**Proposal #15: 1060-53-70, WISC 2024063  
Various Noise Wall Locations  
Locations on STN Per Annual Plan  
Off System  
Milwaukee & Waukesha Counties**

This is Addendum No. 01, which provides for the following:

Addendum No. 01  
ID 1060-53-70  
Revised Sheet 96  
December 6, 2023

GENERAL PLAN & ELEVATION 2	SHEET 2 OF 2
97

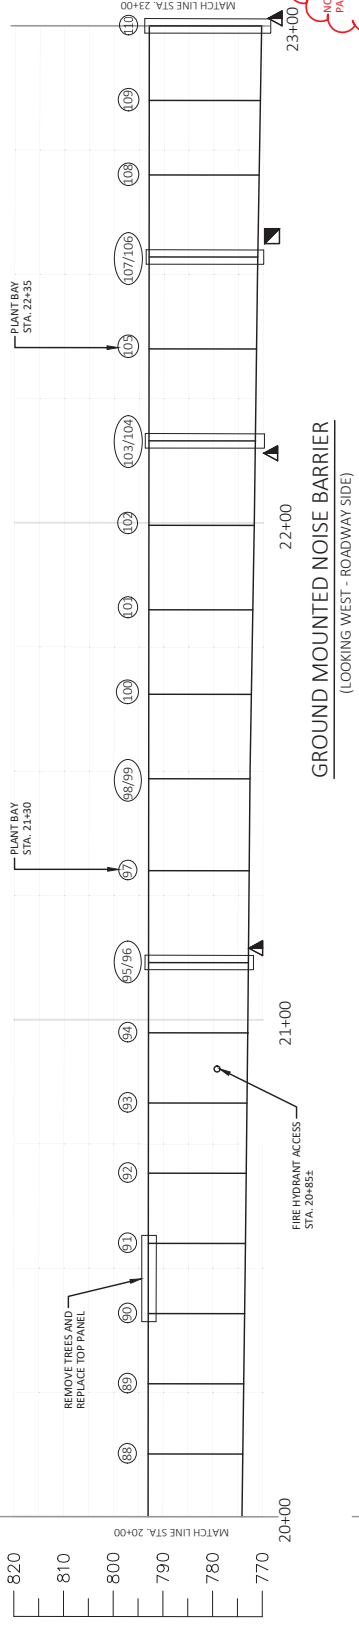
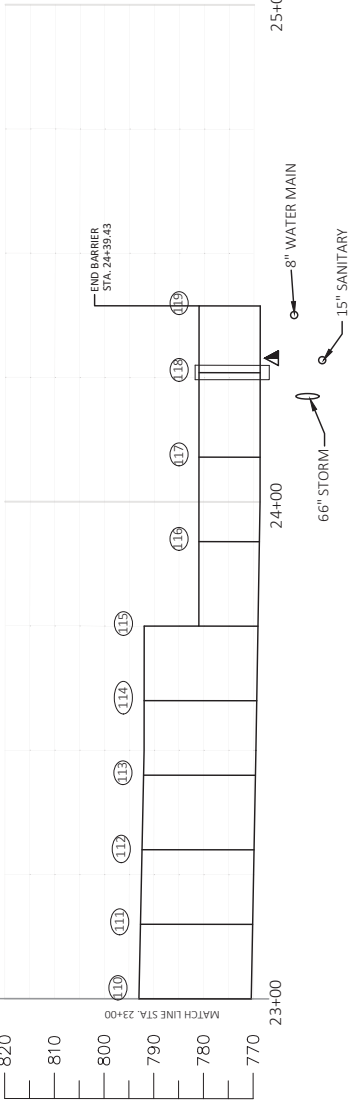
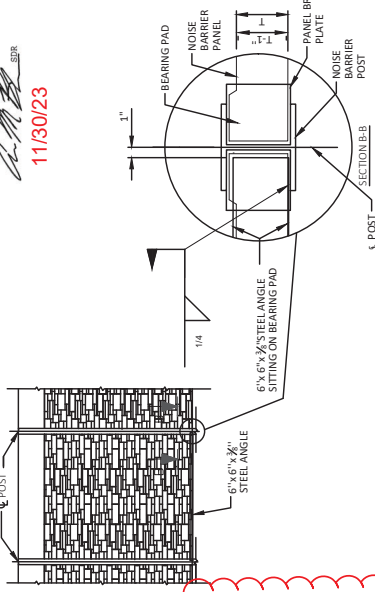
Revised Plan Sheets	
Plan Sheet	Plan Sheet Title (brief description of changes to sheet)
96 & 97	Removed Top Panel Support Repair information and updated quantities. Added Noise Barrier Loading Diagram standard detail.

NO.	DATE	REVISION	BY
1	11/29/23	LOADING & QUANTITIES	JUC
